PLAN REVIEW SHEET

Date:	10/31/2007	Staff Contact:	David McDonald
Petitioner:	North Davidson Acquisitions	Telephone:	704-336-6900
Petition:	2008-004	Fax:	704-432-1277
		Email:	dmcDonald@ci.charlotte.nc.us
Location:	+/- 3.87 acres Northeast corner N. Davidson St and E. 36t St.	Attachments:	Shelter_Concrete_Standards.pdf (See 60.03A)
Existing Zoning:	NS, O-2 and R-5 Commercial Retail, Residential, Parking		
Requested Zoning:	MUDD-O (Development of up to 200k/sf multifamily & up to 60k/sf commercial space, not to exceed 225 residential units)

FIRST SUBMITTAL

STD. NO.	REV.
60.03A

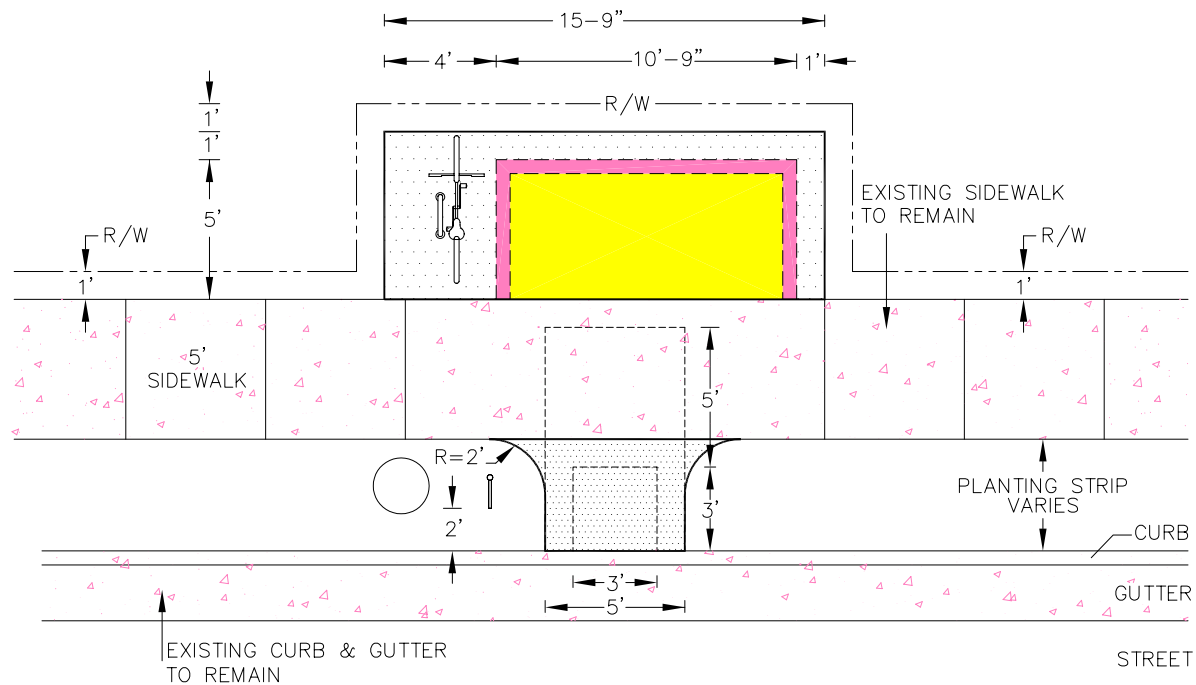
- 1) The petitioner's site is currently served on 36th Street by Route 3 Plaza Road and Route 23 Shamrock Drive.
- 2) CATS requests the petitioner to construct a shelter pad to be located approximately 60' North of the intersection of 36th St. and Alexander St., constructed to CATS Development Standards 60.03 A (see attached).

Please designate such in the site plan and/or accompanying notes. Please contact Leonard Ganther (CATS Operations) @ 704.432.1283 prior to demolition or construction, to coordinate the final location of the new shelter pad.
